TO: Borough of Fair Haven Planning Board

RE: M&M Realty Partners at Fair Haven, LLC
626 River Road
Block 31 Lot 1
Consistency with Settlement Agreement and AH Affordable Housing Zone Ordinance

DATE: October 27, 2021

Comparison of Exhibit A of Amended Settlement Agreement (Concept Plan) and Submitted Site Plan/Architectural Plans

1 - GROUND FLOOR PLAN
 11/11/11

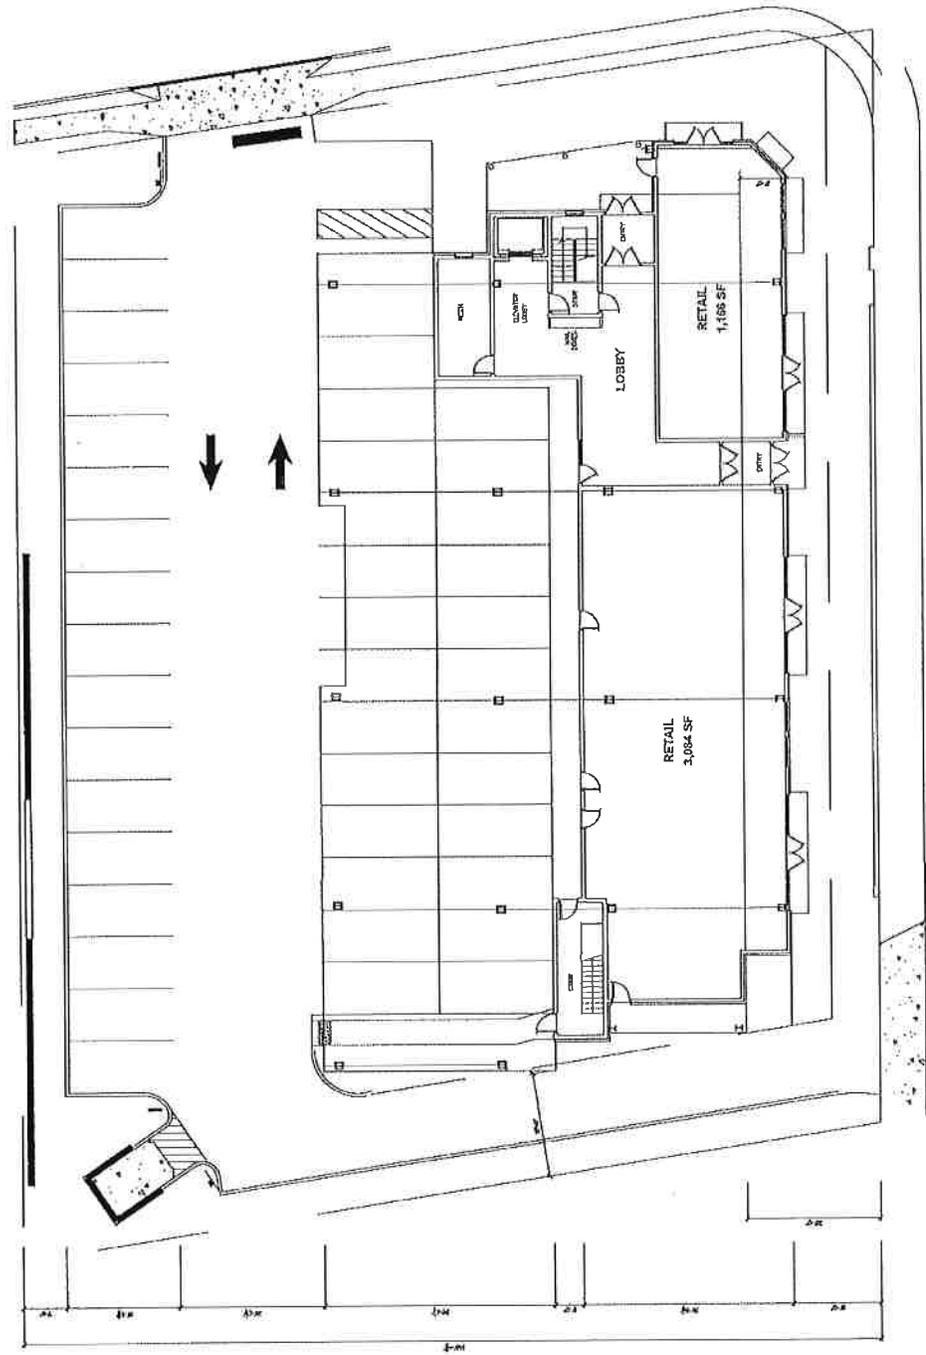
- a. The area designated as the “Lobby” on the first floor of the Concept Plans (included as Exhibit A in the Amended Settlement Agreement) shows access to the lobby from the Cedar Avenue and River Road frontages, as well as through the covered parking area. However, the architectural plans submitted with the application only shows the Lobby area accessible via Cedar Avenue and the parking area.

- b. The footprint of the first-floor has been slightly modified between the Concept Plan and the submitted architectural plans. However, there does not appear to be a change in the floor area of the retail space.

- c. There is an entrance to the retail space located at the corner from Cedar Avenue. The Concept Plan shows awning on the first-floor façade at the corner of the building, where the submitted Architectural Plans do not show awnings at this location.

- d. A separate storage room has been added to the first-floor plans that is only accessible from the covered parking area.
- e. The covered entrance to the residential lobby from Cedar Avenue is reduced in size. The covered entrance is shown on the concept plan extending from the retail store to the residential entrance, where the Site Plan only has the residential entrance covered by the overhang.

THIRD FLOOR PLAN
 11/15/11

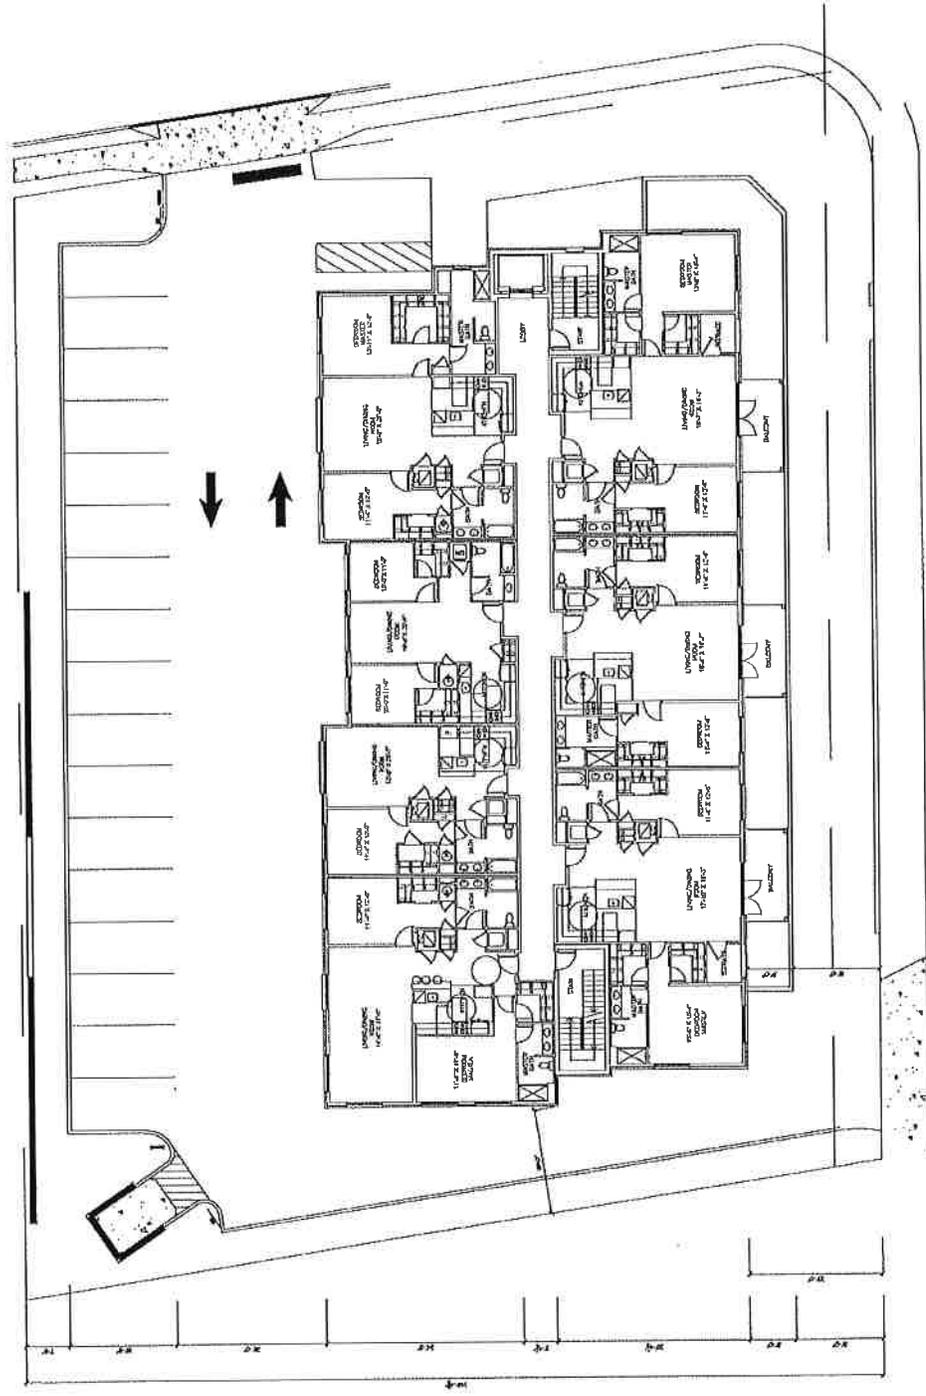
- f. The submitted 2nd and 3rd floor architectural plans appear to be consistent with floor plans that were submitted on the Concept Plan.
- g. Based upon the Area Summary included on Sheet A4 of the architectural plans, the applicant has reduced the overall floor area of the building. The following chart details the differences between the submitted Architectural Plans as part of the Major Site Plan Application and the Concept Plan attached as Exhibit A to the Amended Settlement Agreement:
